**UNITED STATES  
NUCLEAR REGULATORY COMMISSION  
REGION II  
SAM NUNN ATLANTA FEDERAL CENTER  
61 FORSYTH STREET SW SUITE 23T85  
ATLANTA, GEORGIA 30303-8931**

SUBJECT: NRC INSPECTION REPORT NO. 70-1151/2004-001

Report No.: 70-1151/2004-001

Facility: Commercial Nuclear Fuel Plant

Figure 2

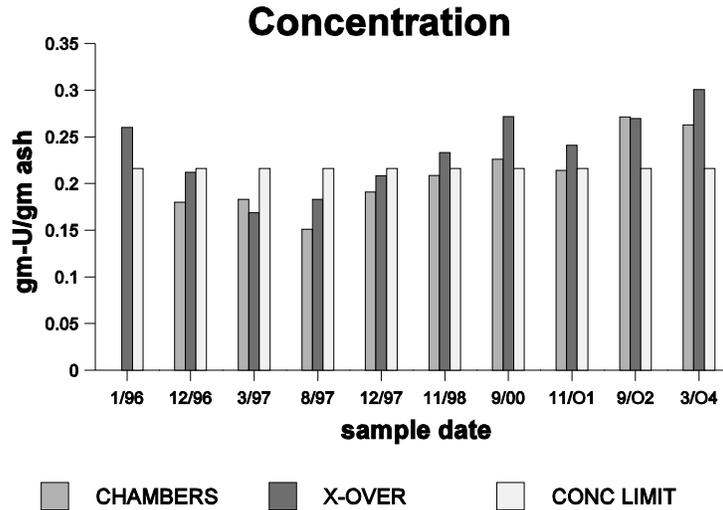
From September 1996 until March 5, 2004, the licensee increased control of burn residence time to improve compliance with environmental regulations and reduced burning of inert materials to reduce solids in the ash which were difficult to clean out of the incinerator. Longer residence time reduces carbon content of the resulting ash thus increasing uranium concentration and allows more time for fly-ash to carry over from the lower combustion chamber. Reduction of inert materials into the incinerator also increases the uranium concentration in the ash. These steady and uncontrolled process changes resulted in gradually increasing uranium concentration throughout the system as shown in Figure #2:

The licensee did not remove material from the upper combustion chamber during every shutdown so that accumulation of mass was likely. Accumulation of sufficient mass in the upper combustion chamber at a concentration that would support criticality is considered credible. Both mass and concentration are seen to increase in Figures #2 and #3 indicating progression of the upset.

**Figure 3**

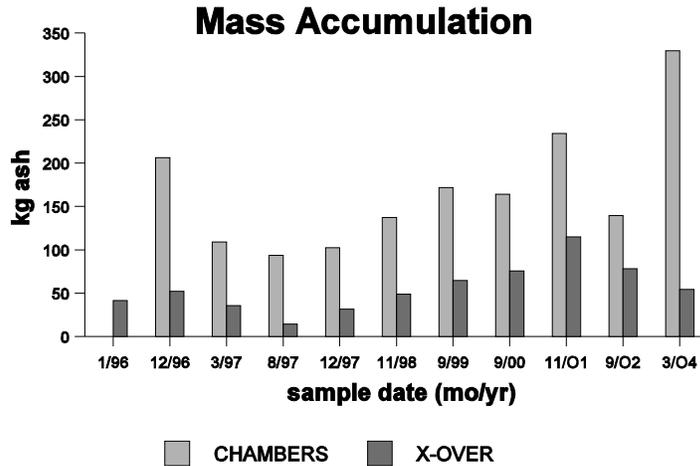
The process changes also resulted in a gradual increase in the amount of ash deposited particularly in the upper combustion chamber and cross-over pipe as shown in Figure #3:
